**ADDENDUM NUMBER 2:  
TOWN OF EXETER, NH  
COURT STREET over LITTLE RIVER  
BRIDGE REPLACEMENT  
CONTRACT DOCUMENTS AND TECHNICAL SPECIFICATIONS**

**Issued: May 15, 2017  
For Bids Due: May 22, 2017**

**PROJECT:** Court Street Little River Bridge Replacement  
Exeter, NH  
CMA Engineers Project No. 923

designed by: LBK/OGK	drawn by: LBK/BGP	approved by: JLG
date: April 2017	project no: -----	file name: R-2.dwg
<p>Town of Exeter Department of Public Works Little River Bridge Replacement Roadway Plan and Profile (Sheet 1 of 2)</p>		
<p>drawing no. <b>R-2</b></p>		
<p>sheet: 24 of 34</p>

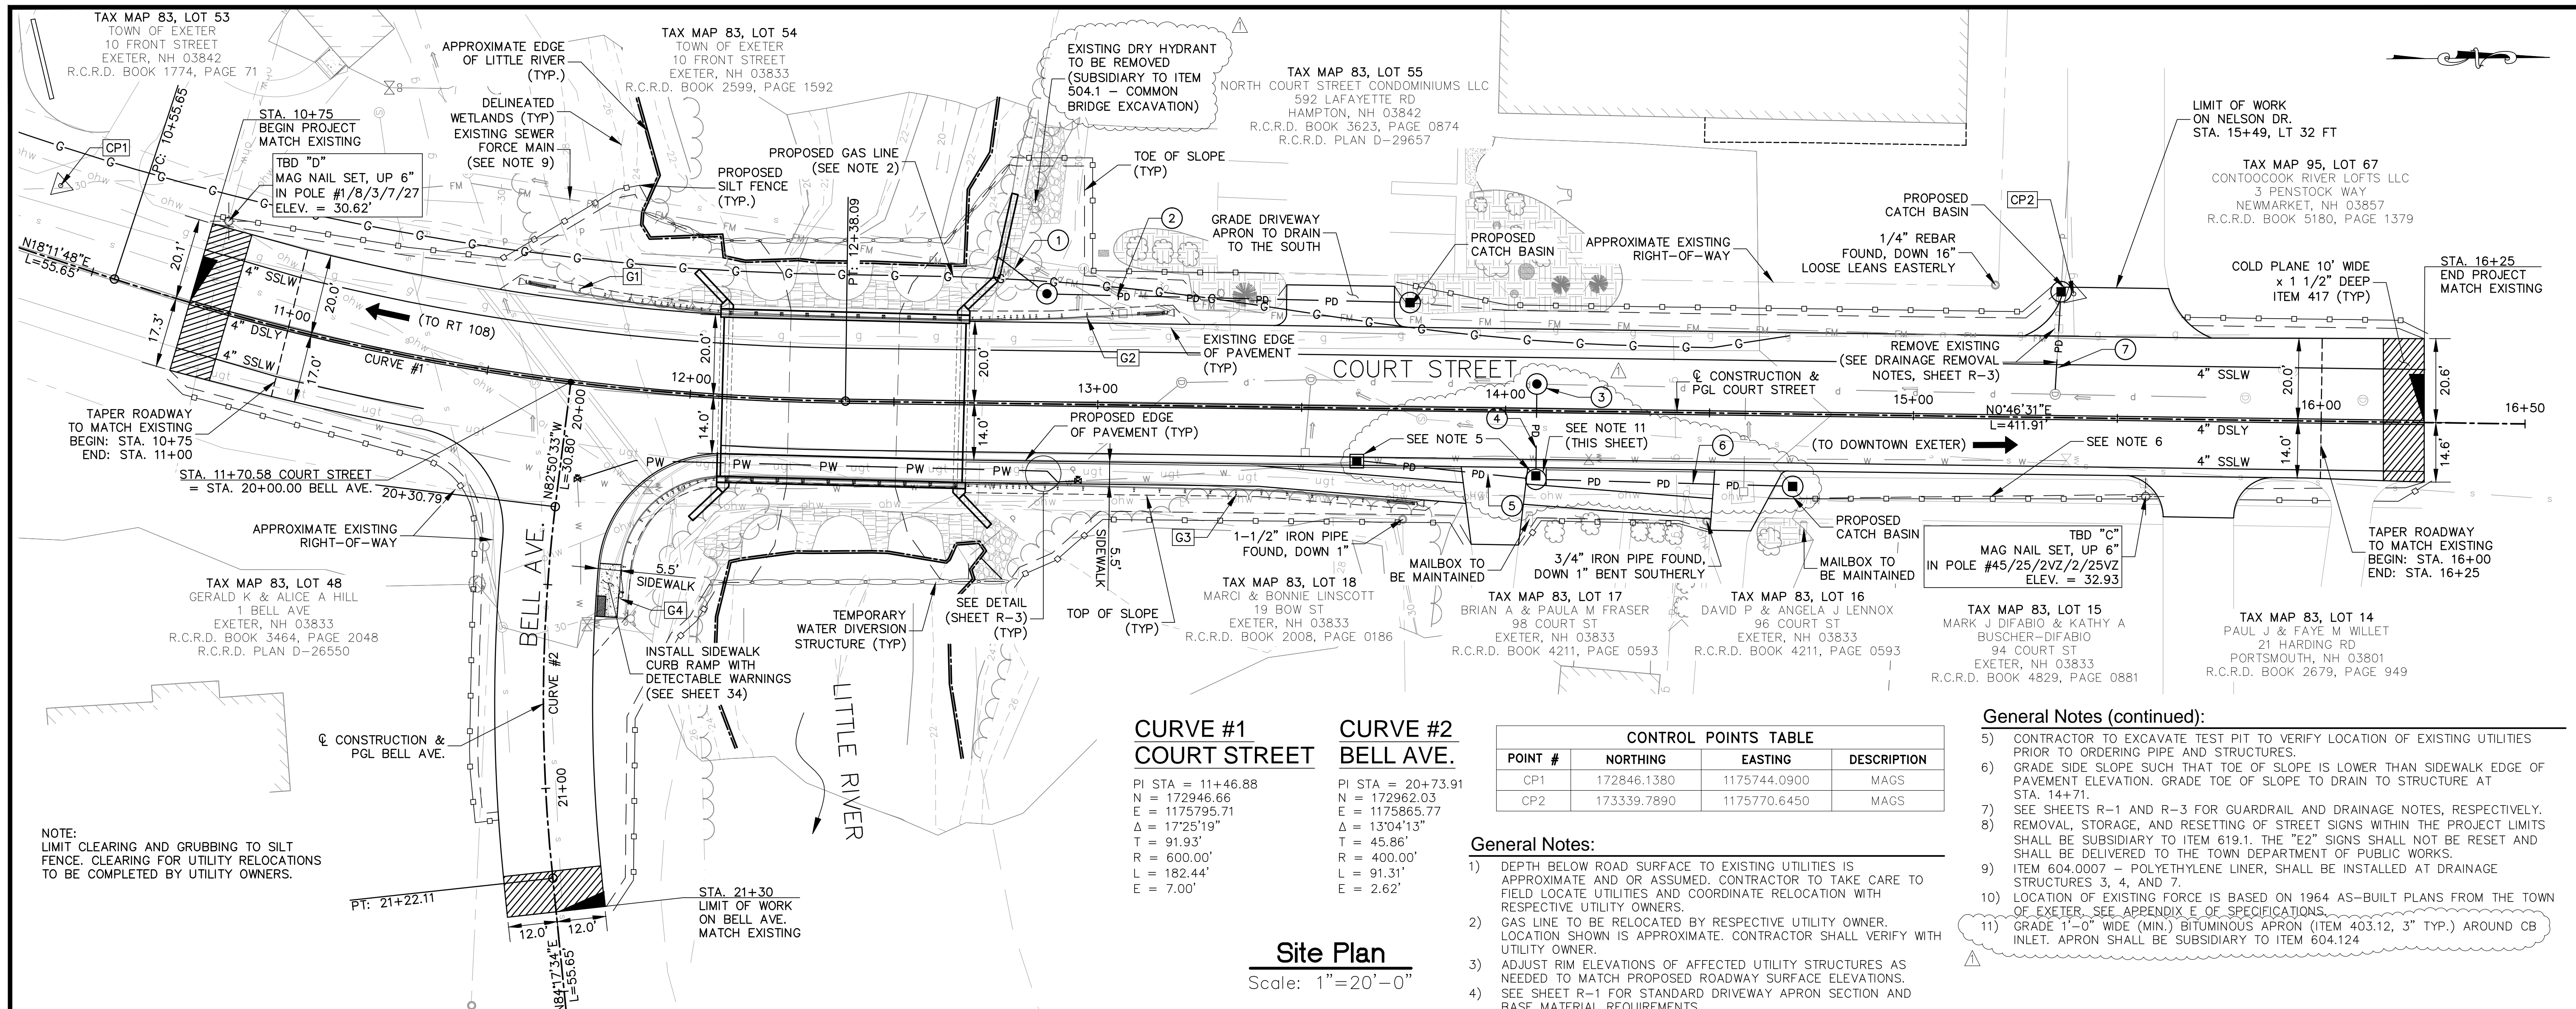
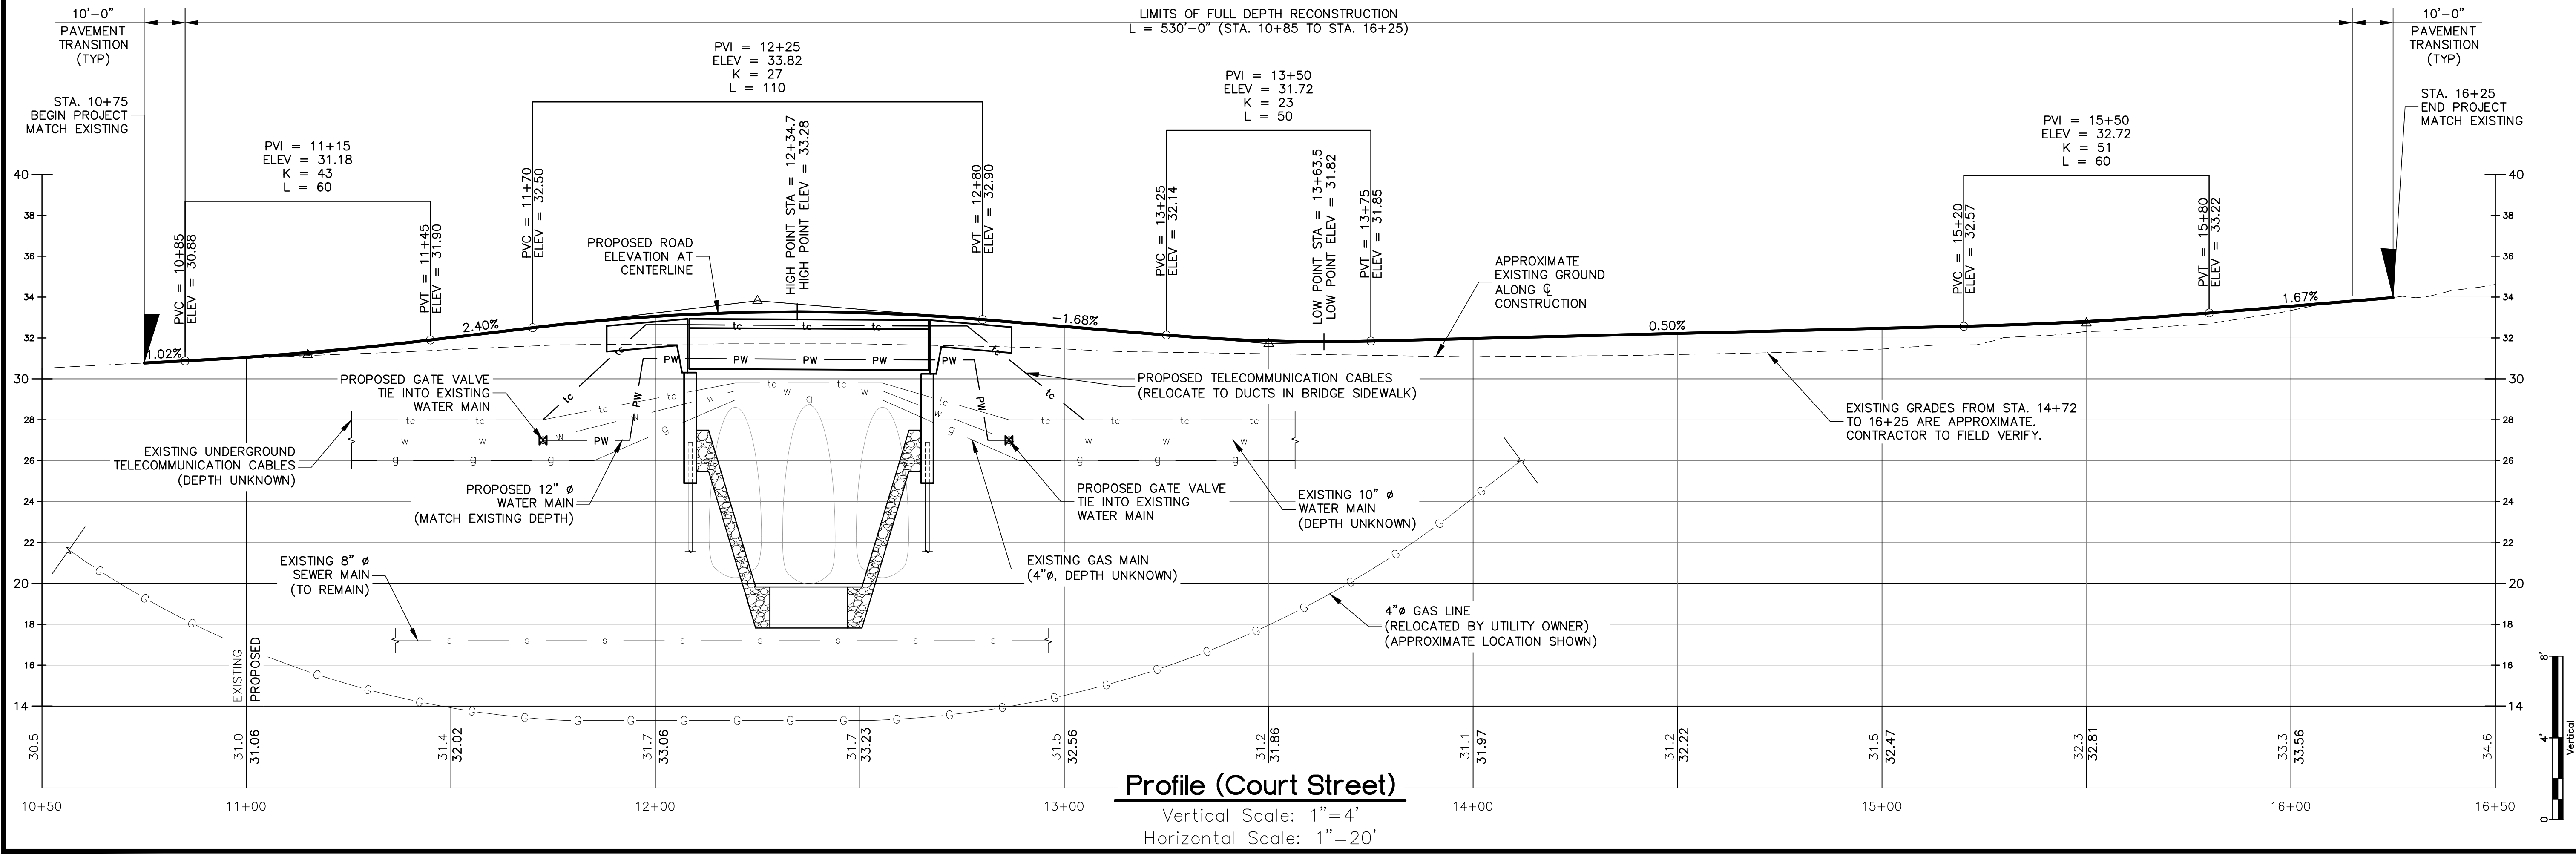
The sheets listed above have been modified to reflect changes to the drainage structures and drainage layout for the project. A note has been added to sheet R-1 to provide clarification regarding the removal of the dry hydrant near the northwest corner of the bridge.

ALTERATIONS TO DRAINAGE LAYOUT  
 1  
 ISSUED FOR BID  
 0  
 no. revision

- General Notes (continued):**
- CONTRACTOR TO EXCAVATE TEST PIT TO VERIFY LOCATION OF EXISTING UTILITIES PRIOR TO ORDERING PIPE AND STRUCTURES.
  - GRADE SIDE SLOPE SUCH THAT TOE OF SLOPE IS LOWER THAN SIDEWALK EDGE OF PAVEMENT ELEVATION. GRADE TOE OF SLOPE TO DRAIN TO STRUCTURE AT STA. 14+71.

- ITEM 604.0007 - POLYETHYLENE LINER, SHALL BE INSTALLED AT DRAINAGE STRUCTURES 3, 4, AND 7.
  - LOCATION OF EXISTING FORCE IS BASED ON 1964 AS-BUILT PLANS FROM THE TOWN OF EXETER. SEE APPENDIX E OF SPECIFICATIONS.
